NUMBER: 18-031-03

4.0L Rough Engine Idle After Restart Following A Hot Soak

This bulletin involves the installation of a fuel injector insulator sleeve.

Fig. 1 SLEEVE INSTALLATION

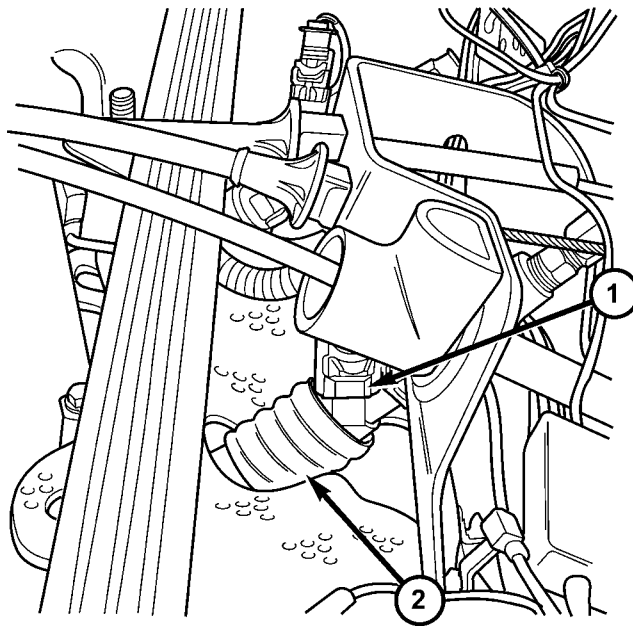
This condition may be caused by heat from the exhaust manifold that following engine shut down migrates to the area around injector #3 and causes fuel vapor to form within the injector. This in turn may cause a momentary misfire of cylinder #3 until the fuel vapor is cleared of injector #3. The insulator sleeve lowers the injector #3 temperature to a point below which the fuel will not normally vaporize.

1. Cut insulator sleeve, p/n 56028371AA, to make two (2) insulator sleeves about 25-30 mm (1 in.) in length.
2. Install one sleeve around injector #3, with the slit on the upward facing side of the injector. Install the other sleeve with the slit on the downward facing side of the injector.
3. Confirm sleeve is flush to intake manifold surface around injector.
4. Check injector #3 wire and ensure that the injector is rotated to a 2 o'clock position (from driver's side of vehicle).
